Final
Environmental Impact Report

Capitol Annex Project

State Clearinghouse No. 2019049066

Final
Environmental Impact Report

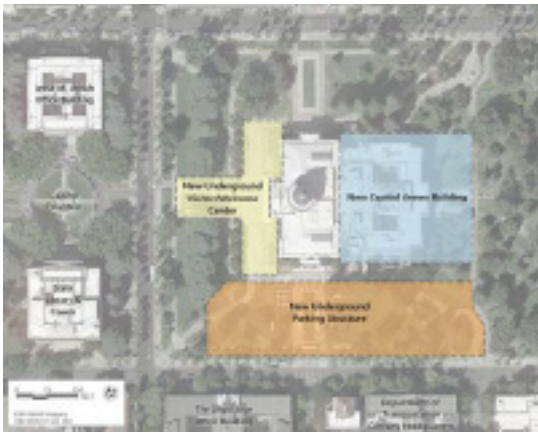
Please note that figure 2-3 in the DEIR, copied below, relative to the proposed footprint of the underground Visitor/Welcome Center, **depicts an area west of the entire historic Capitol building's west façade, and somewhat beyond to the north and south**, not only the area between 10th Street and the west steps of the Capitol.

USE ATRIUM AND EXISTING SIXTH FLOOR, ADD UNDERGROUND SPACE THREE SIDES OF EXISTING ANNEX

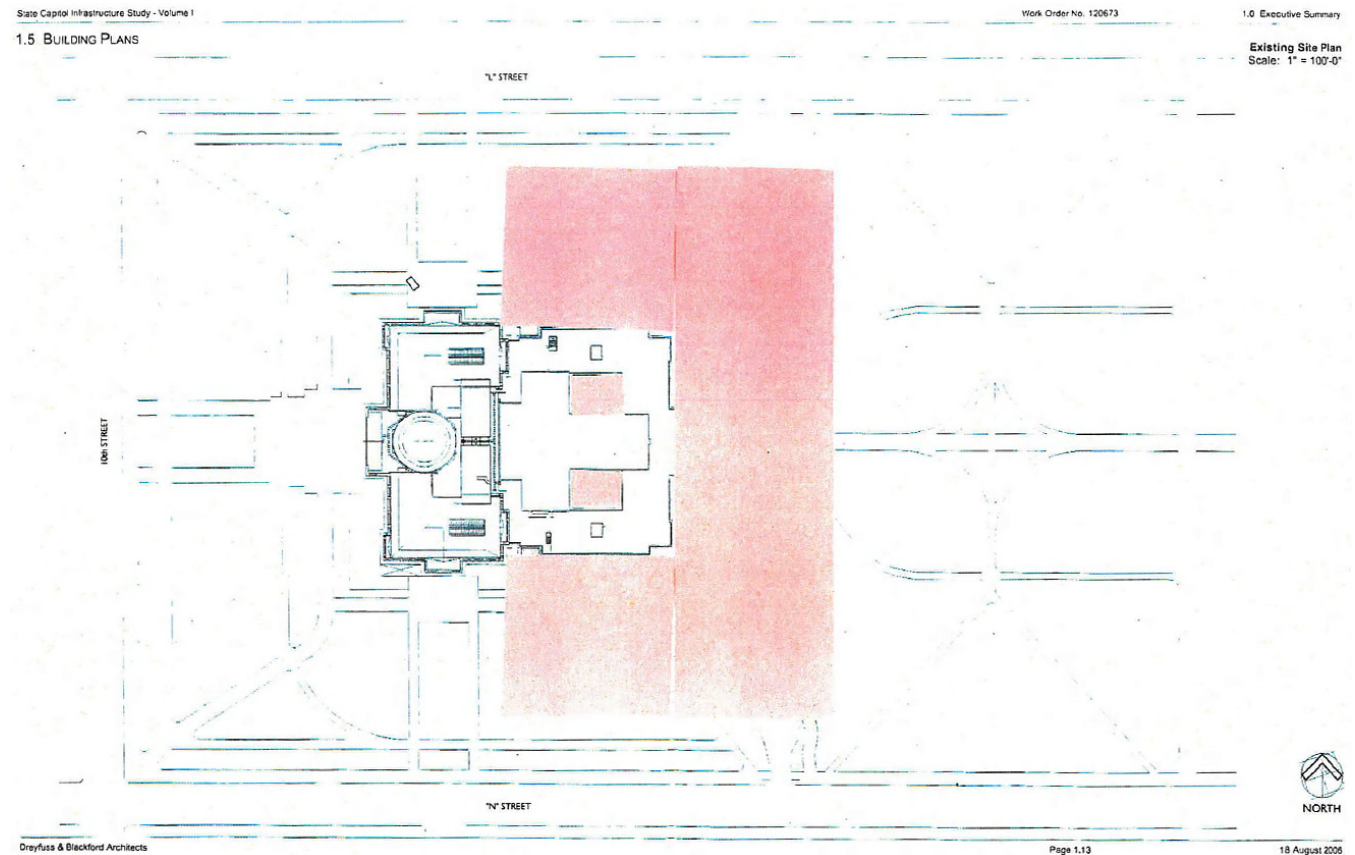
If the atrium spaces were utilized, and the sixth floor fully used, the program could be met by adding approximately 230,000 sf of underground space around three sides of the existing Annex.

Please see Master Response 2.

MOVE ANNEX TO EAST, USE ATRIUM AND SIXTH FLOOR, ADD SPACE IN BETWEEN

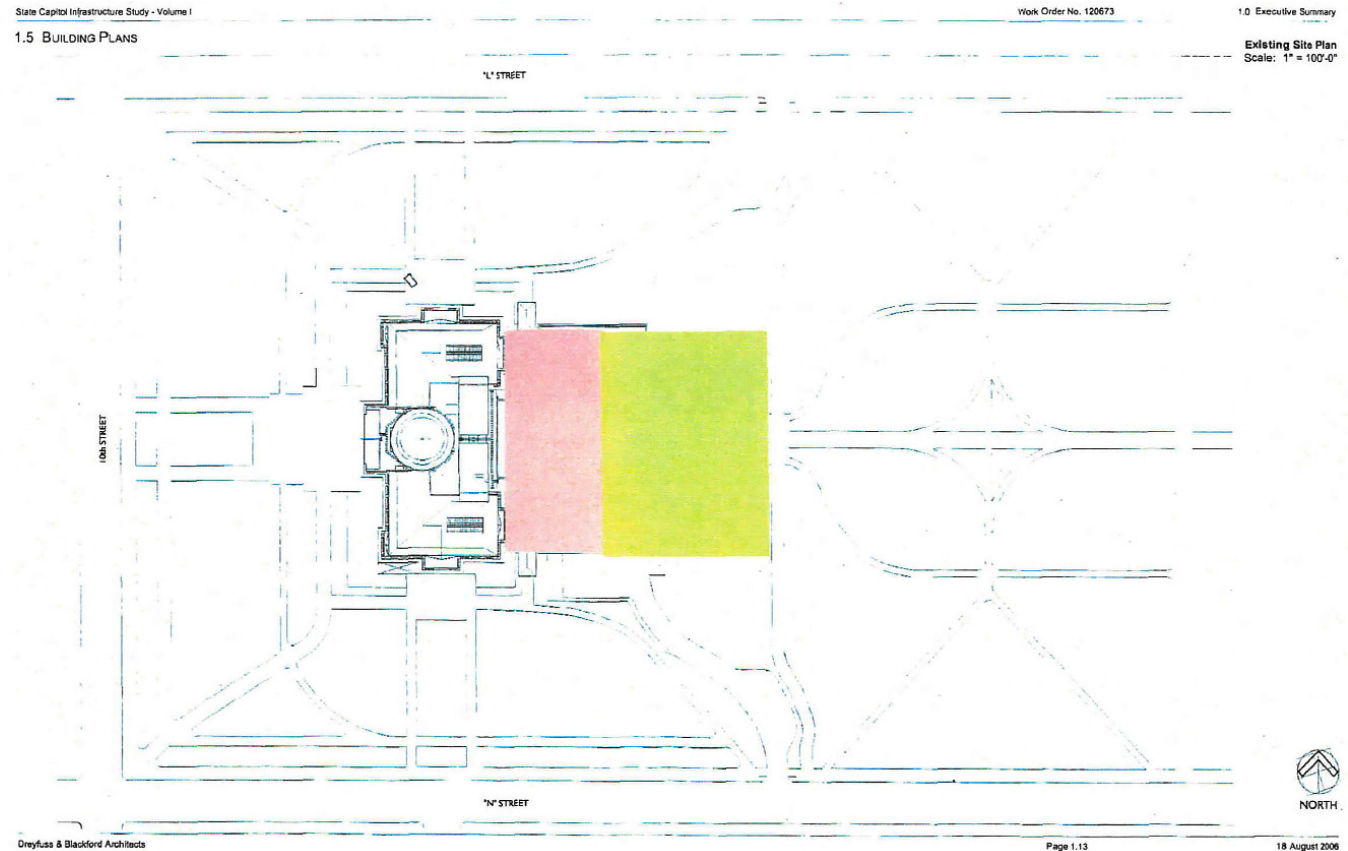
If the atrium spaces were utilized, the sixth floor fully used, and if the existing Annex was moved to the east, the program could be met by adding basement plus five stories in between relocated annex and west wing, better accommodating floor elevation differences.

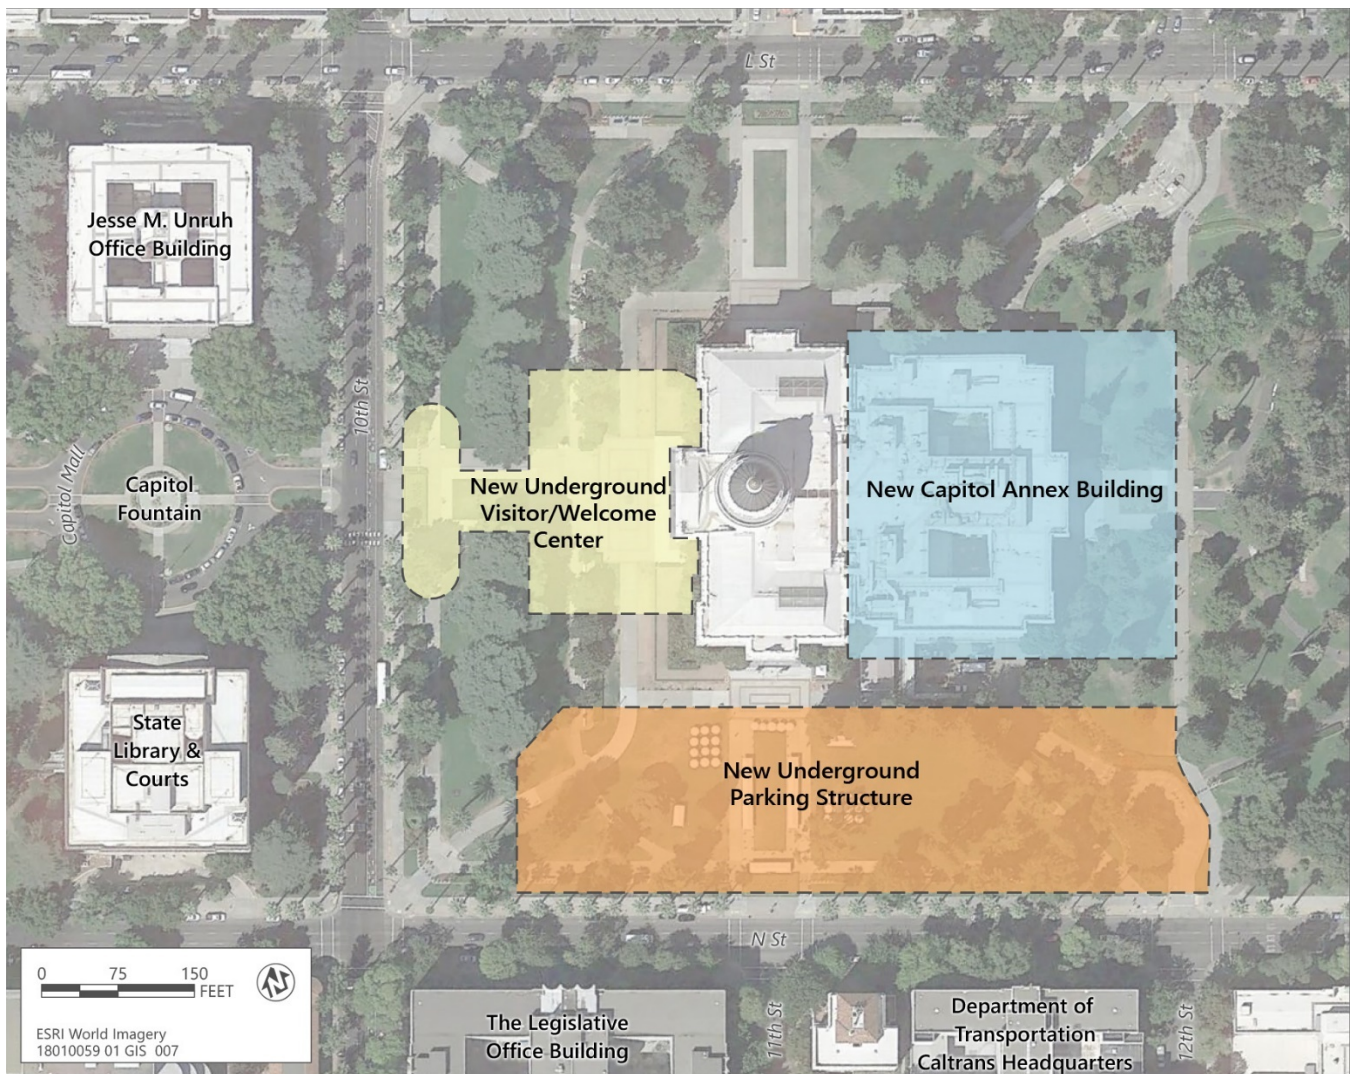
As shown in Figure 3-3 of the Recirculated Draft EIR below, the revised locations of the Visitor/Welcome Center and underground parking structure have potential for damaging five of the historic Deodar cedars, as well as causing removal of multiple other trees. There are 34 trees within the outline of the Visitor/Welcome Center project below. An additional 39 are within the outline of the underground parking structure. Thirty-three more are within the new Annex outline, for a total of 106 trees to be removed or relocated. This represents over 1/10th of all trees in the park. This count does not include those trees within 50 ft of project outlines as mentioned in the original DEIR as part of a protection zone.

For four of the cedars, Figure 3-3 shows that the Visitor/Welcome Center construction will occur well inside the dripline of these trees and on both the east and west sides.
